# Product Change Notification

<b>Date Issued :</b>	March 02, 2023	<b>PCN Number :</b>	513308
<b>Reason for Change :</b>	Change Supplier		
<b>Description of Change :</b>	This notification is to inform you about addition of new supplier for raw cable PNs 711537058 & 711537057. No changes will be made to product as part of this change		
<b>Reason for Short Notice :</b>	Supplier Constraints		
<b>Assessment of Change :</b>	First Article Inspection		
<b>Planned Implementation Date :</b>	May 12, 2023		
<b>Sample Availability Date:</b>	March 31, 2023		
<b>Internal Molex Qualification Date :</b>	April 14, 2023		
<b>Last date to request Samples by Customer :</b>	March 24, 2023		
<b>Traceability Code Markings / Date :</b>	Product made after planned implementation date can contain the change

2156740051 Revision A

Before Picture

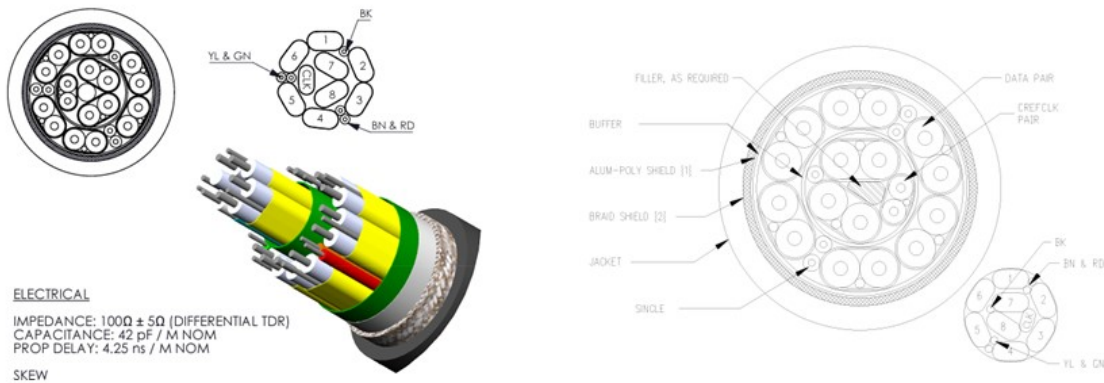
- This notification is to inform you about addition of new supplier for raw cable PNs 711537058 & 711537057. No changes will be made to product as part of this change

- Product Impact
  - No impact to fit, form or function
  - Cable will keep the same quality and performance.
